Work Order ID 152771

Item ID: D212-664-201 Accept ***N900040100*** Setup Start ***NS1***
Revision ID: Stop ***NS2***
Item Name: Aft Crosstube - High
Start Date: 10/28/2016 Start Qty: 1.00 ***1*** Cust Item ID:
Required Date: 11/7/2016 Req'd Qty: 1.00 ***1*** Customer:
Reference:

DART AEROSPACE LTD	Work Order: 152771
Description: Crosstube High Aft (205/212)	Part Number: D212-664-201
Inspection Dwg: D212-664-241 Rev: E	Page 1 of 1

DART SERVICE INSTRUCTION

FIGURE 1: SUPPORT INSTALLATION

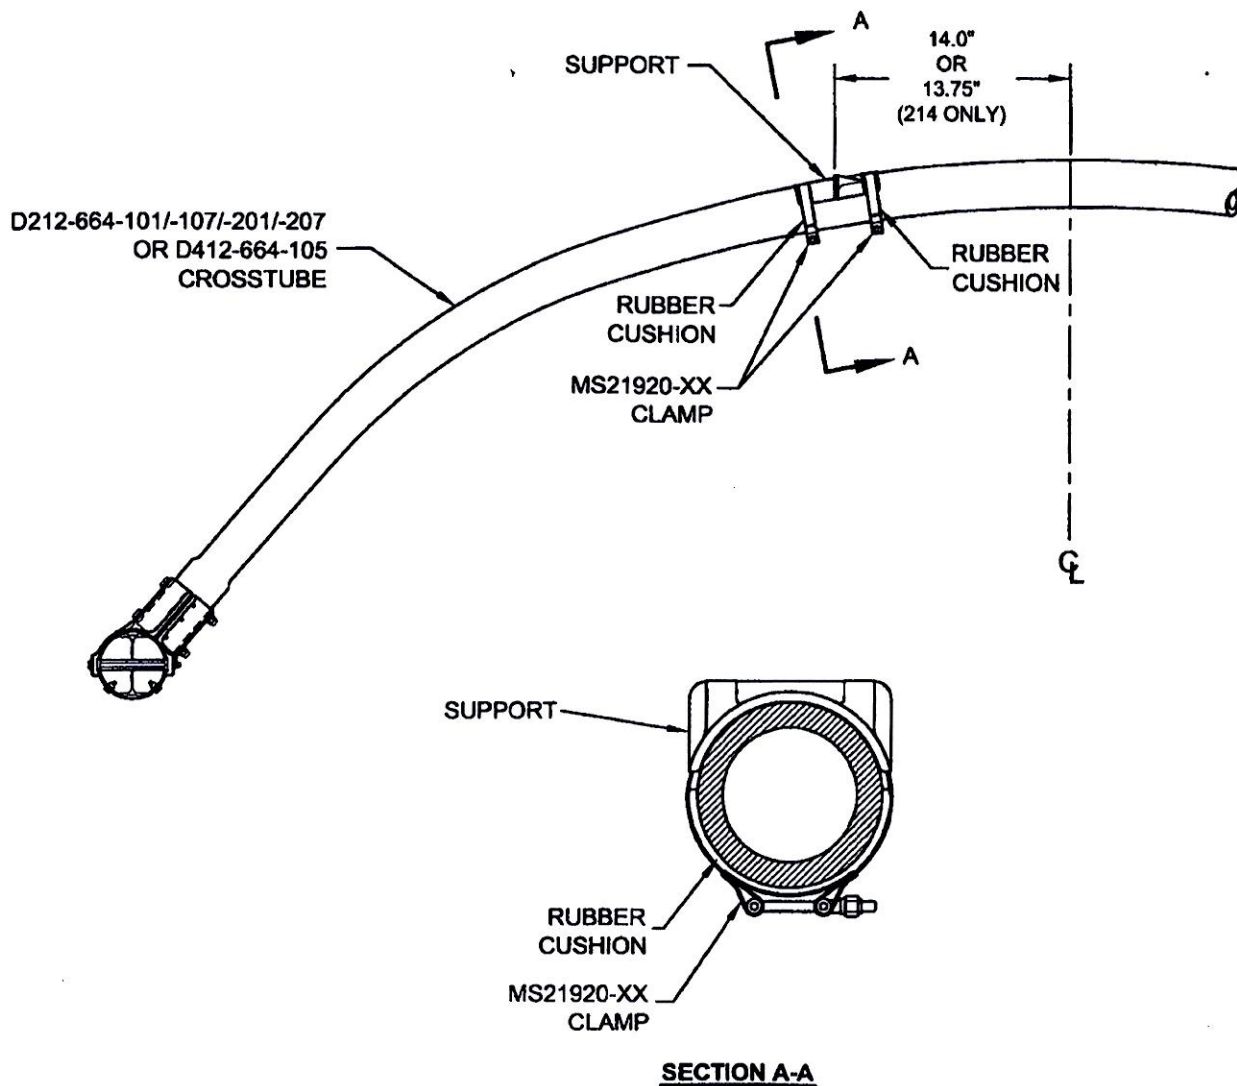
The supports on the following crosstubes are now installed using Proseal instead of Magnobond:

For the crosstubes listed above, section 32.4 of ICA-D212-664 is amended as follows. Use Figure 1 of this service instruction and Figures 32-2 to 32-9 of ICA-D212-664 for further reference. For crosstubes of an earlier change number, it is recommended that if the supports are removed, the supports should be reinstalled using the procedure listed below.

- 32.4.5 Apply a 0.04" to 0.07" thick layer of Proseal 890 Class B or AMS-S-8802 Class B sealant underneath applicable support and install support as shown in Figure 1 of this service instruction.

- 32.4.6 Install the clamps opposite to crosstube support as shown in section A-A of Figure 1. Install rubber cushions underneath each clamp around the bottom circumference of the crosstube up to the crosstube centerline. Torque clamps 80-100 in-lb (9.0-11.3 Nm). It is acceptable to use smaller or larger sized MS21920-XX clamps than those listed in ICA-D212-664, ensure that after torquing the clamps per this instruction, the nuts are in safety but not bottomed out
